**LOSS OF POWER TO UPFITTER INSTALLED  
SYSTEMS AND ACCESSORIES**

TSB 13-9-1

2011 F-53 Motorhome Chassis,  
F-59 Commercial Stripped Chass

This article supersedes TSB 13-8-6 to update the Service Procedure Illustration.

Figure 1 - Article 13-9-1

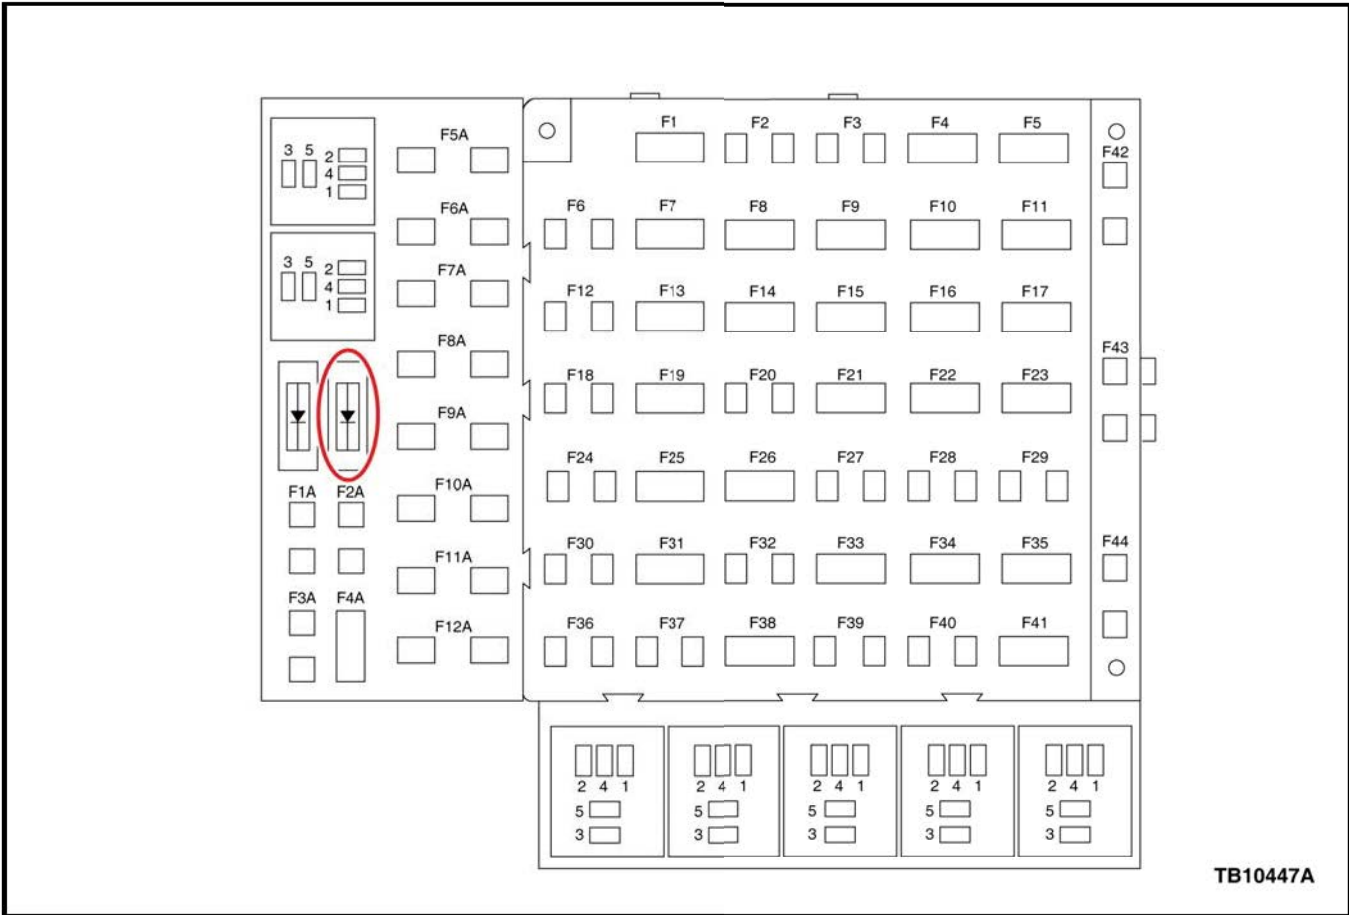
1. Disconnect all batteries.
2. Remove accessory diode from CJB. Refer to Wiring Diagram, Section 11-1.
3. Access rear of CJB, as required.
4. Modify circuit 294, as illustrated. (Figures 1 and 2)

a. Cut circuit 294 as it enters the CJB from fuse 38.

b. Seal circuit 294 going to accessory diode with heat shrink tube.

Figure 2 - Article 13-9-1

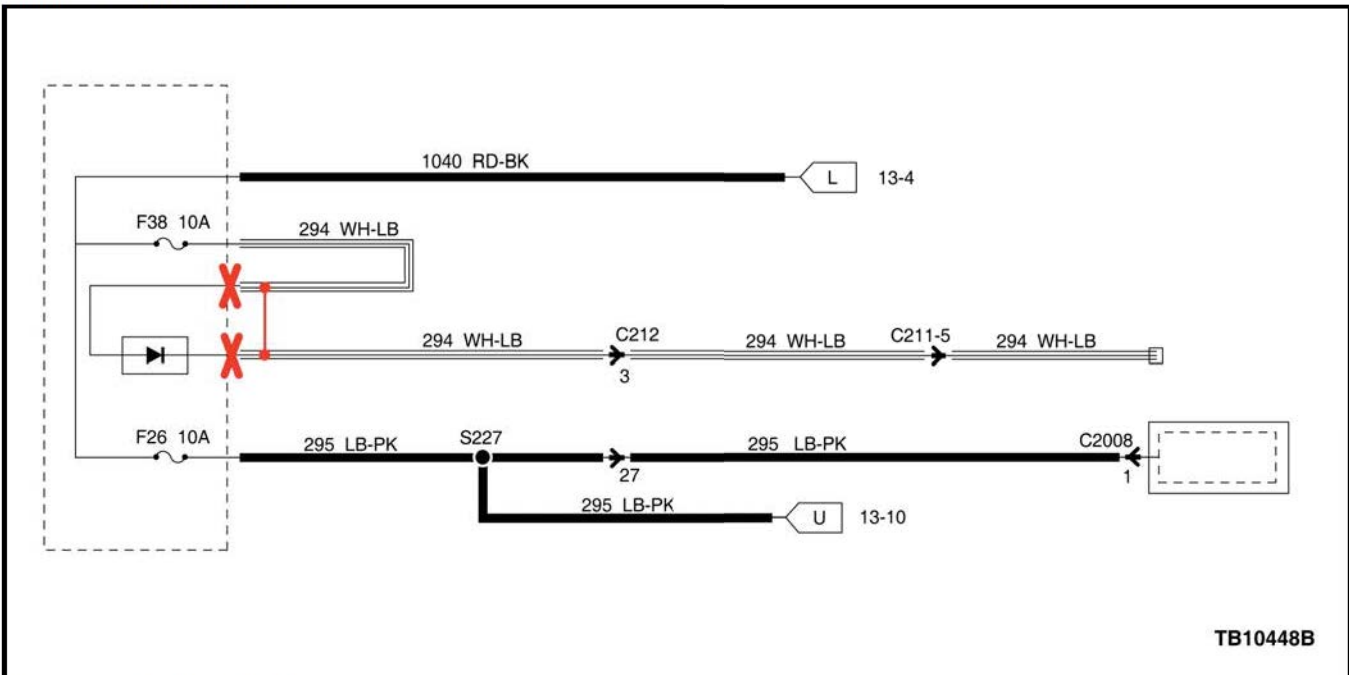
- c. Cut circuit 294 from accessory diode.
- d. Seal circuit 294 from accessory diode with heat shrink tube.
- e. Splice circuit 294 from fuse 38 to circuit 294 harness side and seal with heat shrink tube. Refer to Wiring Diagram, Section 5-6. (Figure 2)
